Access Compliance Report

Public Rights-of-Way

(Curb Ramps)

Intersection ID: 19209		Main Street: LIVINGSTON_DR		Cross Street: SARDIS_RD		Location: NE			
ADA ID: BFF1E8AE5BFB		Ramp Type: Perp		Initial Pass/Fail: Fail		Overall Compliance: No		Severity Score: 12.5	
Codes/Mitigation Info/Possible Solution					Field Measurements/Component Compliance

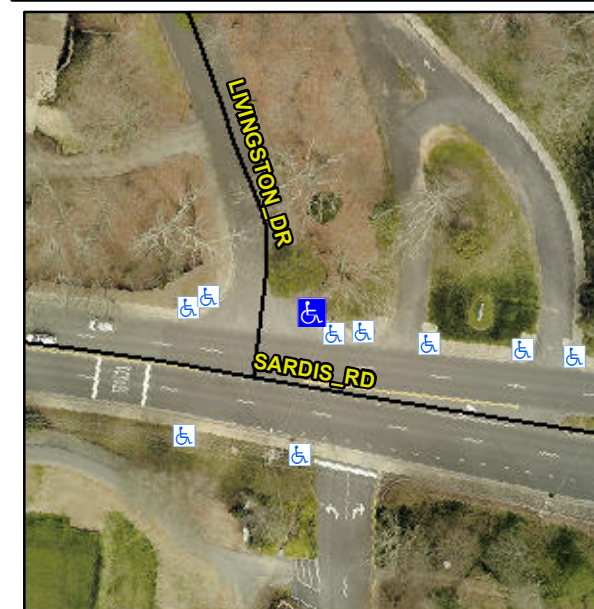
Not Found, R304.2.2

Compliance	Description	Data	Compliance	Description	Data
N/A	Ramp Length (in)	59.0	No	Ramp Slope (%)	10.1
Yes	Ramp Width (in)	48.0	Yes	Ramp XSlope (%)	0.1
N/A	Flare Type LT	N/A	N/A	Flare Type RT	N/A
N/A	Flare Slope LT (%)	N/A	N/A	Flare Slope RT (%)	N/A
N/A	Flare Traversable LT?	N/A	N/A	Flare Traversable RT?	N/A
N/A	Landing Length (in)	N/A	N/A	DWS Provided?	N/A
N/A	Landing Width (in)	N/A	N/A	DWS Contrast?	N/A
N/A	Landing Slope (%)	N/A	N/A	DWS Length (in)	N/A
N/A	Landing X Slope (%)	N/A	N/A	DWS Full Width?	N/A
N/A	Landing Curb? (Y/N)	N/A	N/A	DWS Offset (in)	N/A
N/A	Shared Landing?	N/A			
N/A	Gutter Ponding?	N/A	N/A	Gutter Slope (%)	N/A
N/A	Gutter Lip Ht (in)	N/A	N/A	Gutter X Slope (%)	N/A
N/A	Painted X Walk1?	No	N/A	Painted X Walk2?	N/A
	X Walk 1 Direction	To NW		X Walk 2 Direction	N/A
N/A	X Walk 1 Width (in)	N/A	N/A	X Walk 2 Width (in)	N/A
	X Walk 1 Slope (%)	0.3		X Walk 2 Slope (%)	N/A
	X Walk 1 X Slope (%)	0.5		X Walk 2 X Slope (%)	N/A

Remove & Replace Entire Ramp.
